Agenda

of the e-Plenary Meeting of the
FAI Aeromodelling Commission

To be held via Zoom conference Call Application
on 7th May 2022

14.1 Volume CIAM General Rules, Section 4C

b) Annex 4J – F2B Manoeuvre Diagrams

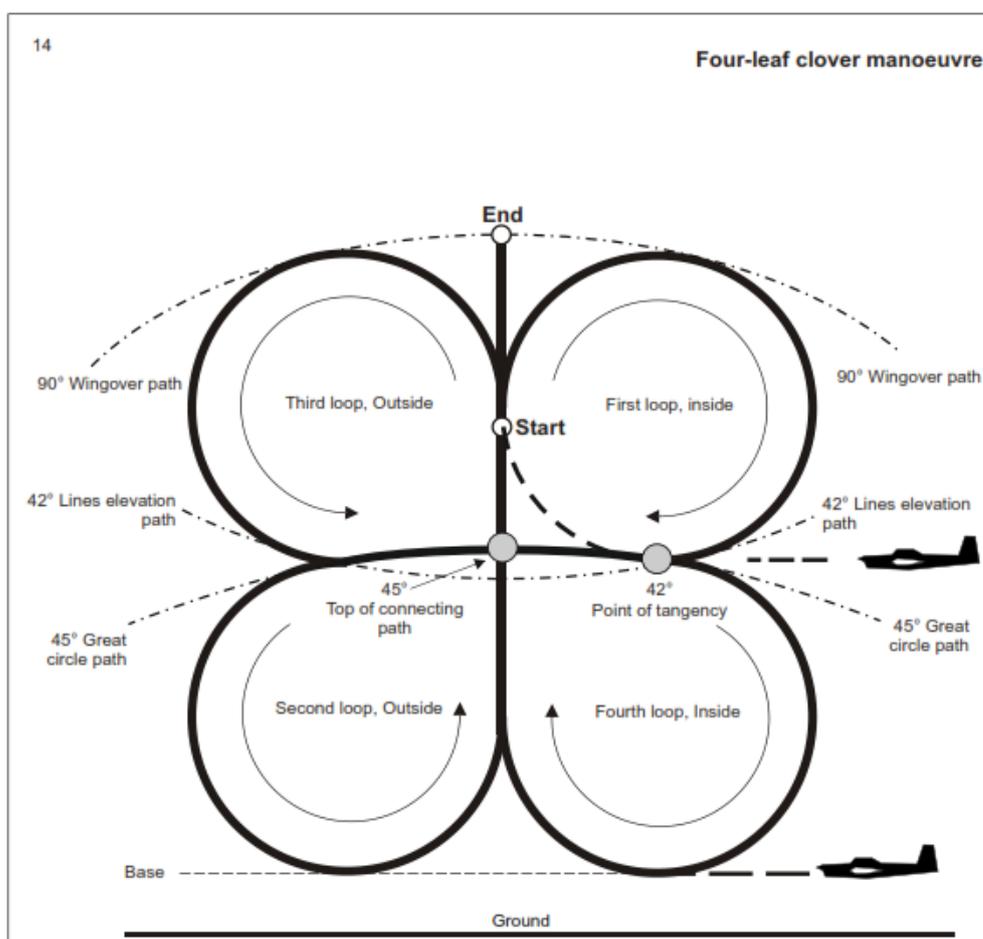
Replace 4.J.14 Four-leaf clover manoeuvre diagram (Rule 4.2.15.16):

Reasons: Clarification with added dotted lines showing manoeuvre entry and horizontal segments flight tracks.

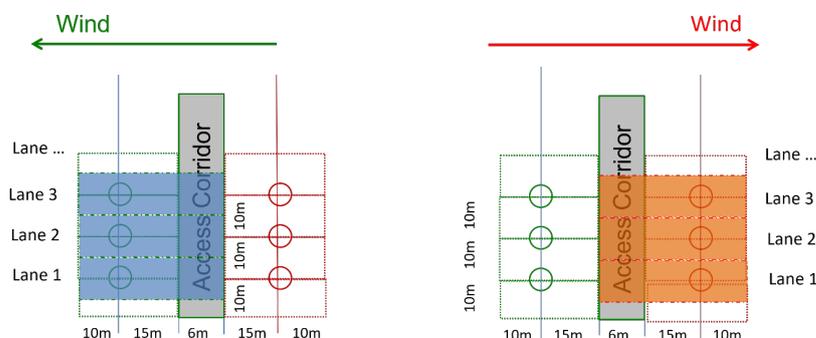
Throughout the whole flight, the pilot and his helper(s) must be in a 10 metre wide rectangular area from the starting line to 10 metres behind the landing point, the centre of which is formed by a straight line between starting point and landing point. A penalty of 100 points will be applied for any breach of this rule.

Reason: The proposed rule change is designed to:

- Enhance safety. As
 - o a pilot being far away from the landing spot cannot be approached by CD or Timekeeper.
 - o Pilots trying to hit the landing spot from far away put people (other Pilots, Helpers, Timekeepers) in proximity to the landing spots in danger.
 - o Pilots on their way back to the landing zone late in the working time (fast pace running) are at risk of impeding other pilots
 - o Pilots on their way back to the landing zone late in the working time (fast pace running) are at risk of losing control over their model in case of stumbling or falling.
